Technical Service Bulletin: tsb180136

Released Date: 05-Dec-2018

Belt Shredding

Figure 3. Updated drive layout with 3-idler bracket

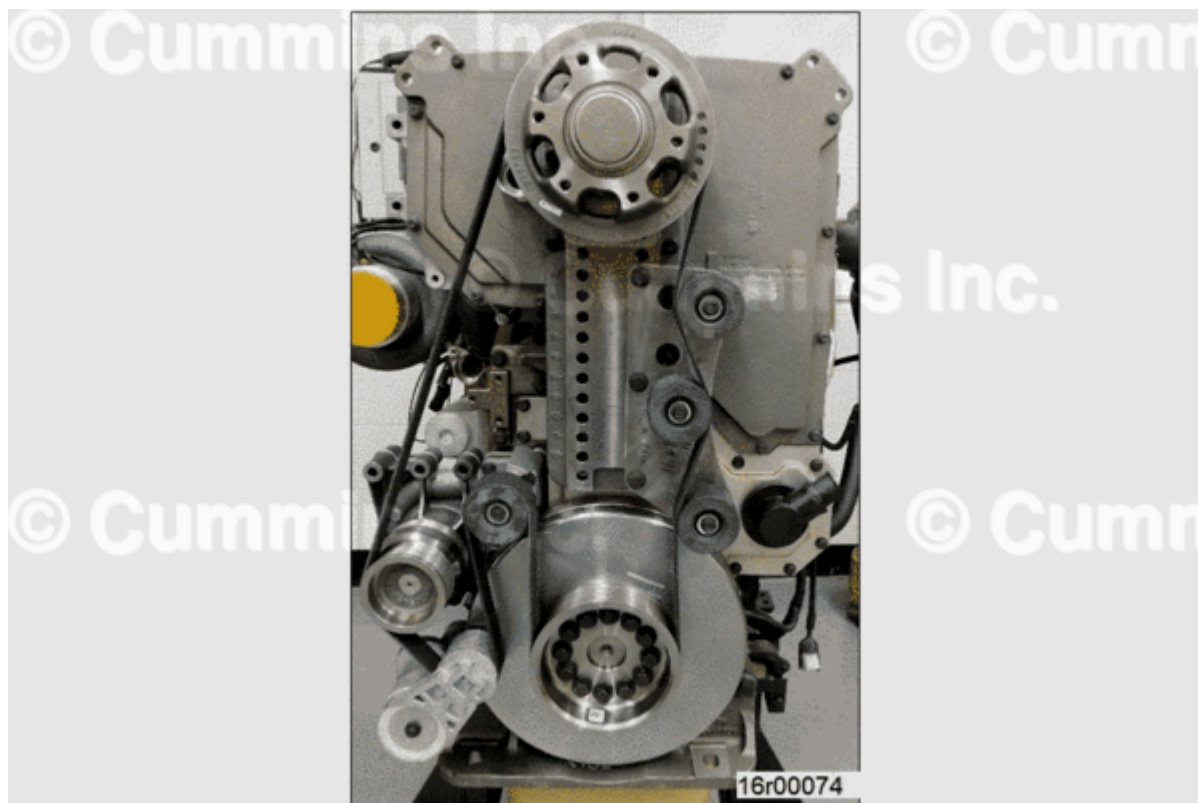
A new 3-idler pulley bracket for engines with specific high mount fan centers (fan drive options FA1542 and FA1657). The 3-idler pulley bracket is mounted on fan bracket between fan and crankshaft pulley. See Figure 3 below.

- Remove fan support bracket (ladder bracket).
 - Reference Procedure 008-088 in Section 8.
- Install idler pulley bracket Part Number 5575127 to fan support bracket. bottom hole of idler pulley bracket should line up with bottom right hole of fan support bracket. See Figure 3. Use hex nut Part Number 3035803 and capscrew Part Number 3093940.
 - Tighten capscrews to 75 N-m [55 ft-lb]
- Reinstall fan support bracket.
 - Reference Procedure 008-088 in Section 8.

- Install idler pulley bracket Part Number 5575127 to fan support bracket (removed in previous step). The bottom hole of idler pulley bracket should line up with bottom right hole of fan support bracket. See Figure 3. Use hex nut Part Number 3035803 and capscrew Part Number 3093940.
 - Tighten capscrews to 75 N-m [55 ft-lb]
- Reinstall fan bracket.
 - Reference Procedure 008-088 in Section 8.
- Install idler pulley Part Number 3681587 to idler pulley bracket Part Number 5575127. Use capscrews Part Number 3 3903112 and washers Part Number 3 3026269.
 - Tighten capscrew to 46 N-m [34 ft-lb]
- Install dust shield Part Number 3935013 to idler pulley by pressing on outside diameter of shield to prevent damage to dust shield.
 - Reference Procedure 008-030 in Section 8.
- Install fan drive belt, Part Number 3103848.
 - Reference Procedure 008-002 in Section 8.

Figure 4, FA1542 Drive Layout.

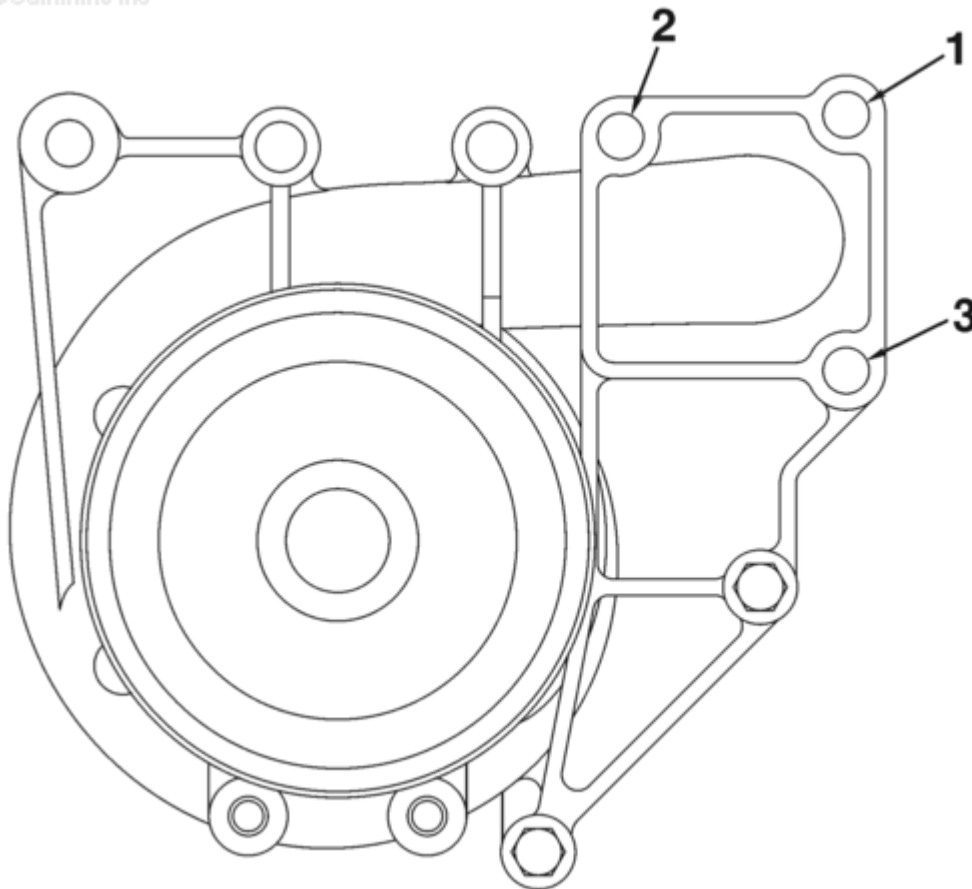
Verify that engine currently has FA1542 installed. See Figure 1 below. The belt cooling fan belt tensioner will be installed in middle of drive, directly above crankshaft pulley.

- Remove fan drive belt, belt cooling fan belt tensioner, and cooling fan belt tensioner support from fan bracket.
 - See QSX15 CM570 Service Manual, Bulletin number 3666239. Reference Procedures 008-002 and 008-080 in Section 8.
 - Remove three capscrews on right side of water pump. See Figure 5 below.

- Install belt cooling fan belt tensioner bracket, Part Number 3681191. Use capscrews removed from water pump. Capscrew 1 is Part Number 3681390 and capscrews 2 and 3 are Part Number 3093936. Capscrew 1 requires washer Part Number 3036460 and Capscrew 3 requires washer Part Number 3009330.
 - Tighten all capscrews to 58 N-m [43 ft-lb]
- Install pilot adapter Part Number 3681587, using dowel pin Part Number 70760, and idler pulley Part Number 3681587.
 - Reference Procedure 008-062 in Section 8.
- Install low-mount large cooling fan belt tensioner Part Number 3104029.
 - Reference Procedure 008-080 in Section 8 – "For low-mount (large cooling fan belt tensioner)".

Figure 6, FA1657 Drive Layout.

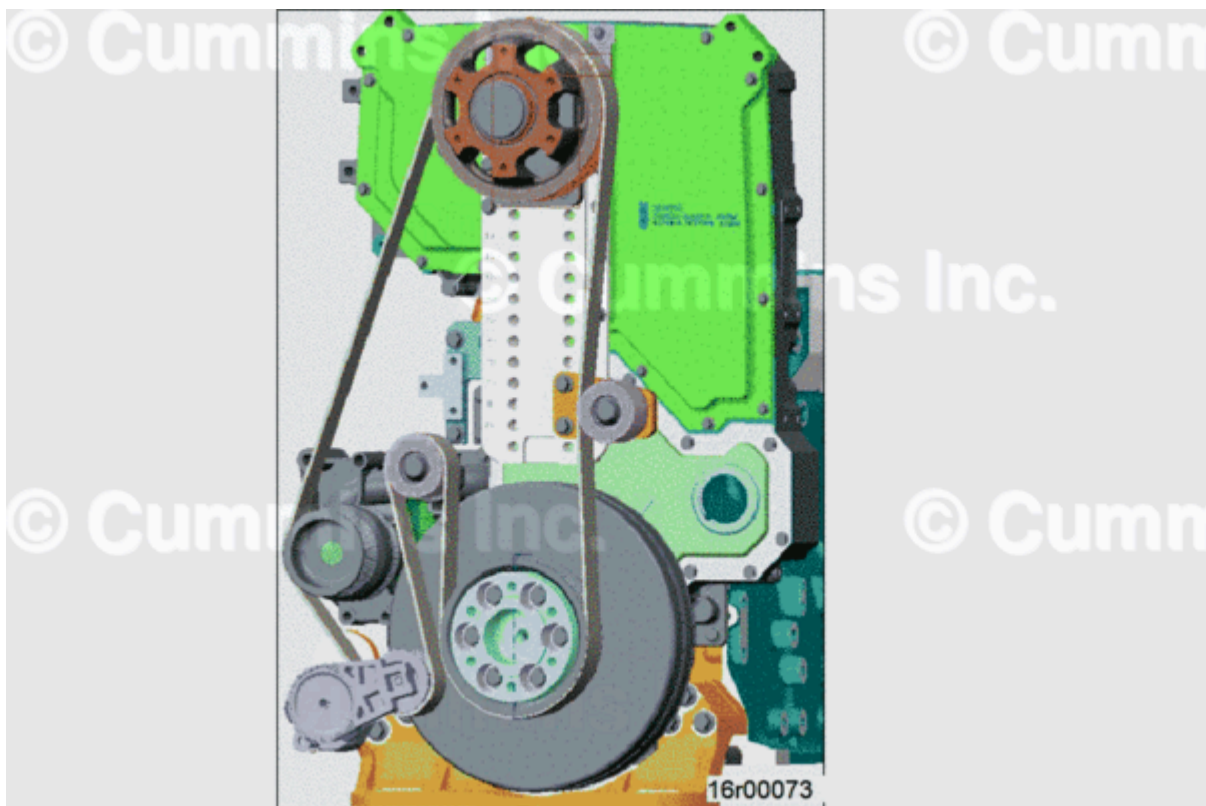
- Verify engine has FA1657 option. See Figure 6 below.
- Tensioner will be installed on low engine mount and there will be an idler pulley directly above crankshaft pulley. There will be a tight side idler pulley, too.

- Remove fan drive belt.
 - Reference Procedure 008-002 in Section 8.
- Remove fan support bracket (ladder bracket).
 - Reference Procedure 008-088 in Section 8.
- Remove tight side idler bracket that is attached to fan support bracket with two capscrews.
 - Do **not** reinstall fan support bracket until new idler bracket is installed.
